SUBJECT: COMANCHE PEAK STEAM ELECTRIC STATION (CPSES)  
DOCKET NOS. 50-446  
TRANSMITTAL OF INSERVICE INSPECTION PROGRAM PLAN  
INTERIM CHANGE REQUEST  
(UNIT 2: 1986 EDITION OF ASME CODE SECTION XI, NO ADDENDA,  
INTERVAL START DATE - AUGUST 3, 1993, FIRST INTERVAL)

Interim Change Request No. ISI-2R0-006

INTERIM CHANGE REQUEST

Plan Title/Rev. Unit 2 ASME Section II Inservice Inspection Program Plan 10 ICR No. 6

9604220338-09

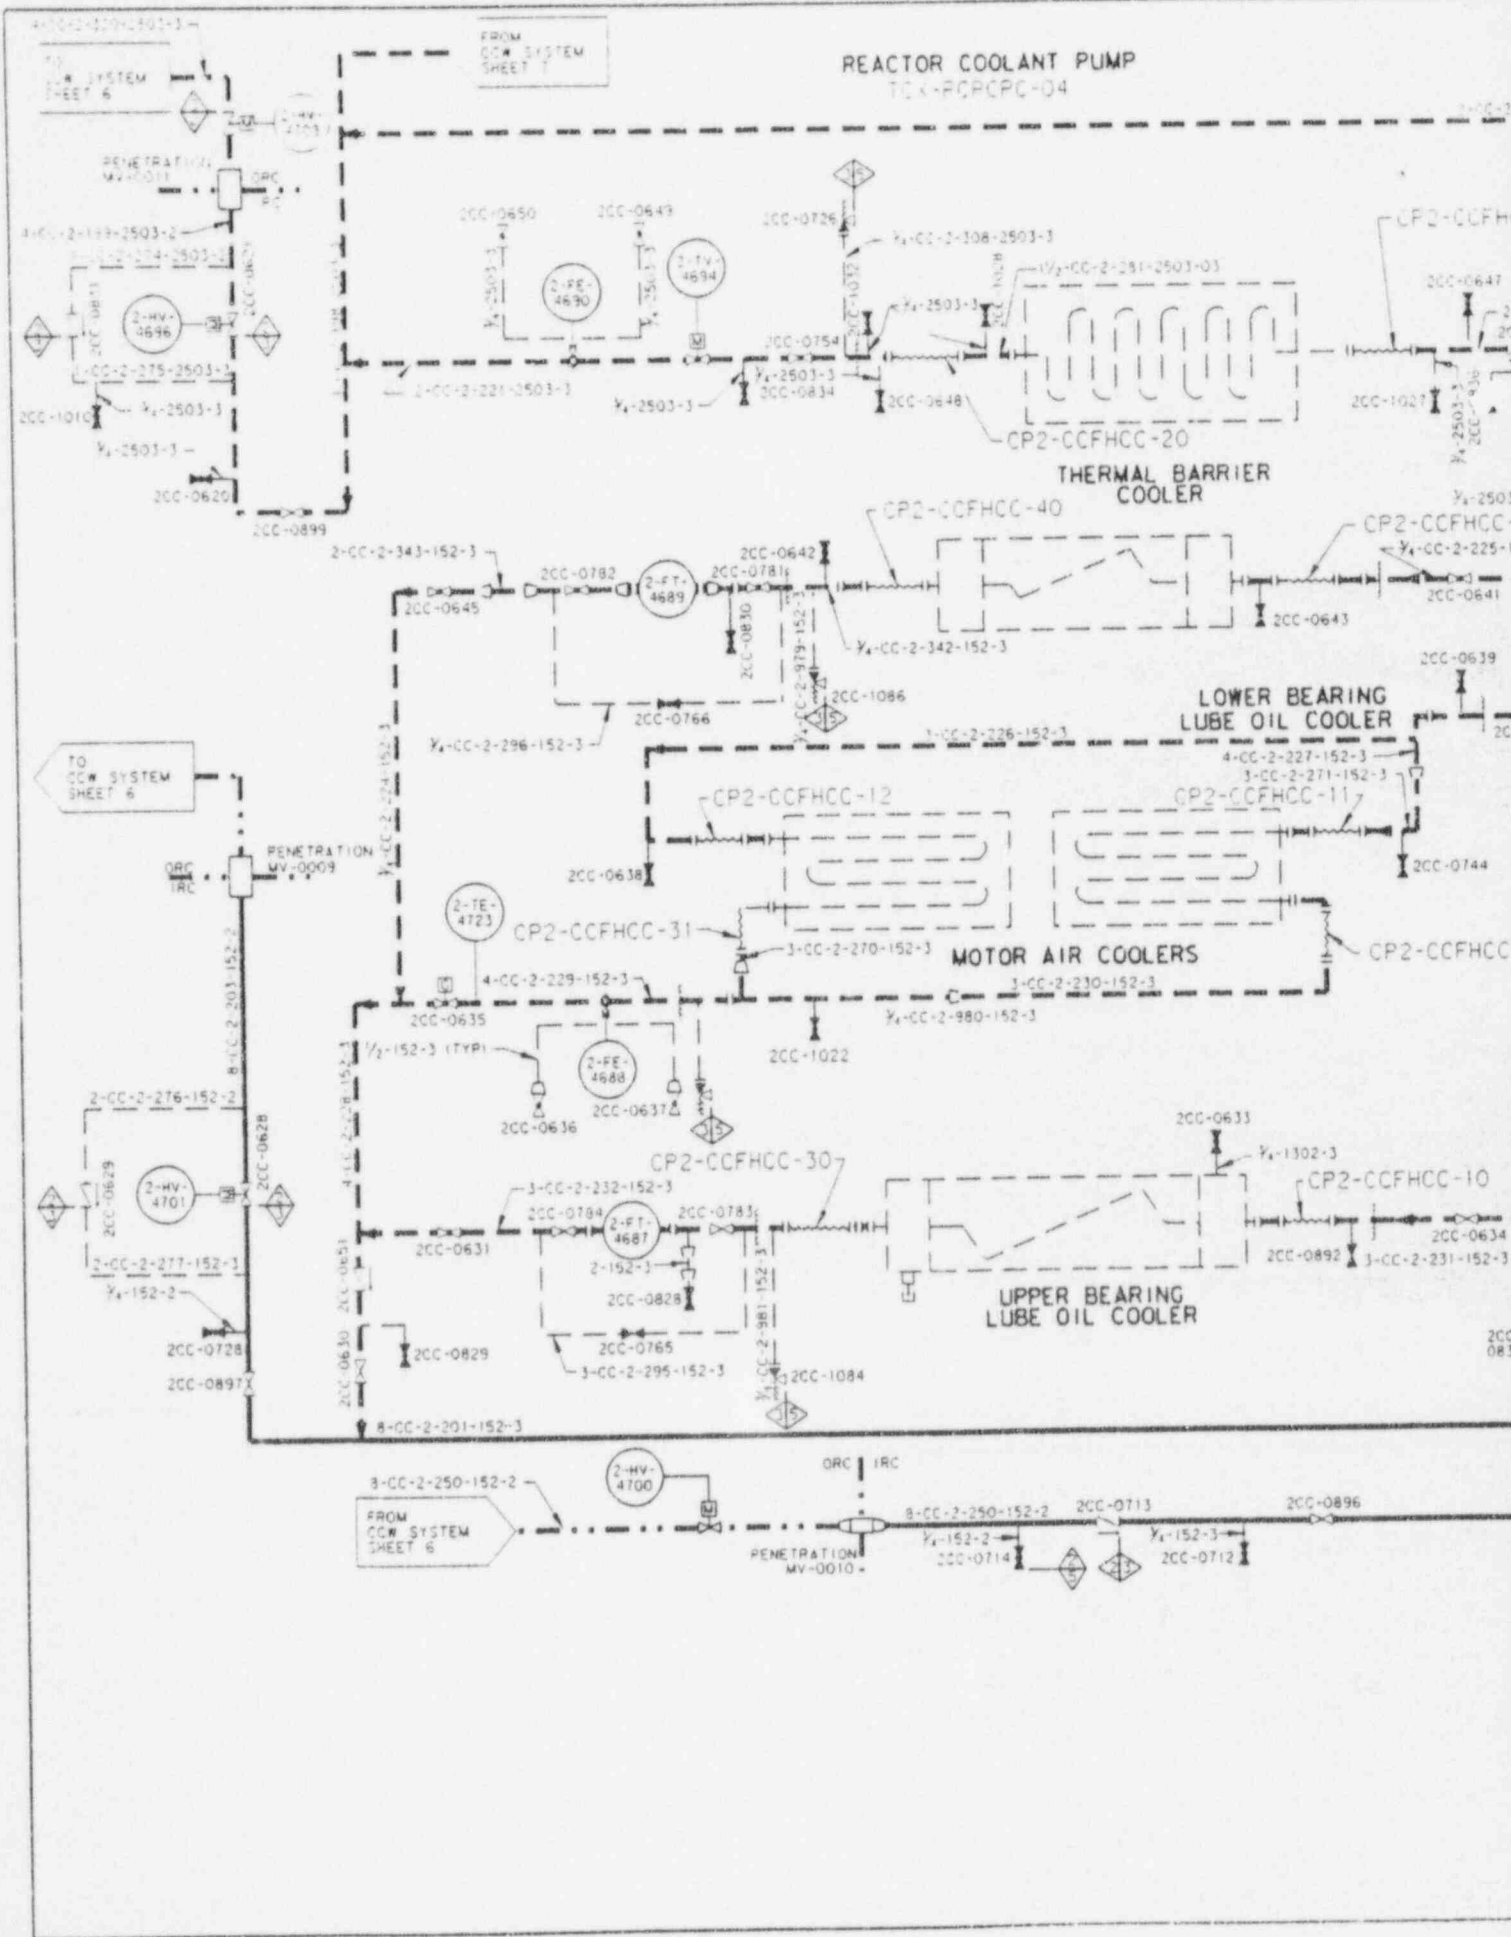
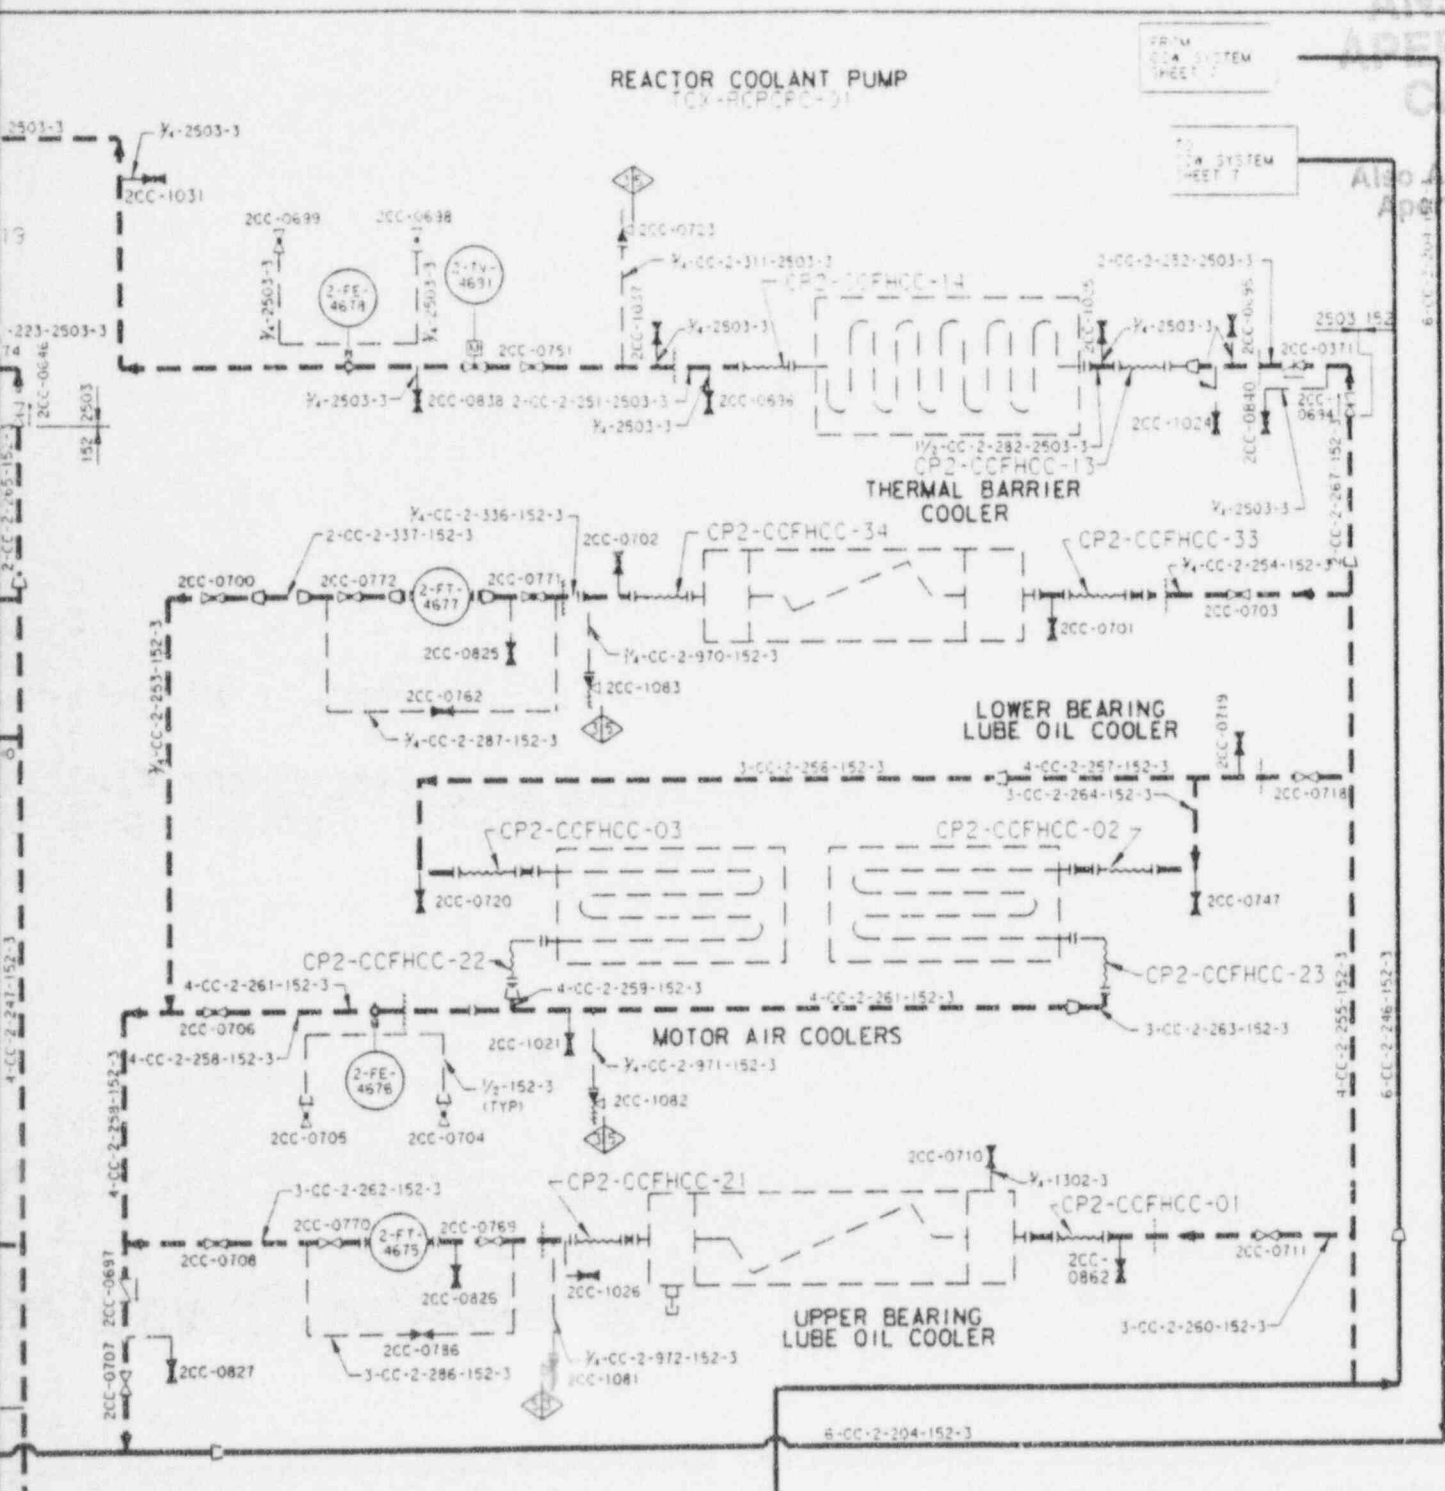
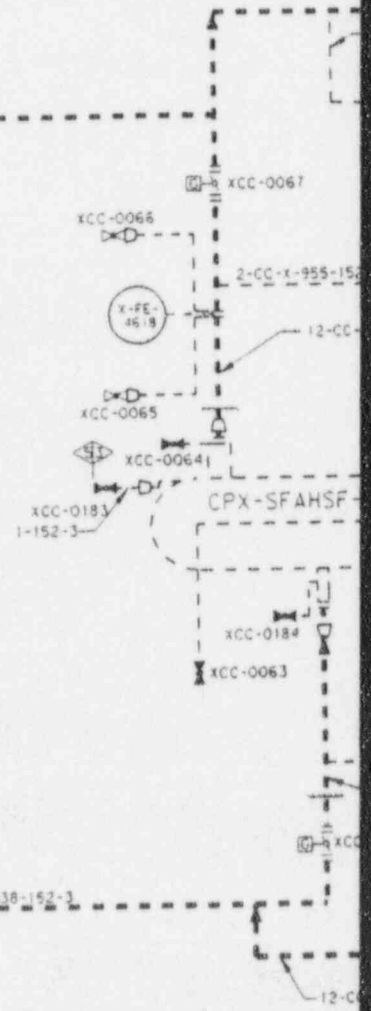
1. CC - Three 24" crossties are provided between Units 1 and 2. Each crosstie is between locked closed butterfly valves. As described in DBD-ME-229, these crossties are not required for any design base accident or safe shutdown. Therefore they do not meet any of the criteria established in Table D-A, D-B or D-C.

The portion of CC which is between containment isolation valves 2-HV-4711 and 2-HV-4710 (both ORC) supplies flow to the shell side of the Reactor Coolant Drain Tank Hx and the Excess Letdown Hx. The Excess Letdown Hx accommodates expansion related flow in excess of the capabilities of normal CVCS letdown during plant heatup. The Reactor Coolant Drain Tank is part of the Waste Processing (WP) system. As described in DBD-ME-264, "Liquid Waste Processing System", the WP system does not perform a safety function. Valves 2-HV-4710/4711 close upon an S-signal. Therefore, the requirements of Category C-H note (7) are met.

Replace Table 9 of Section 5.0 with the attached. Replace the existing drawing with the attached drawings as listed below. A detailed justification of this change is attached.
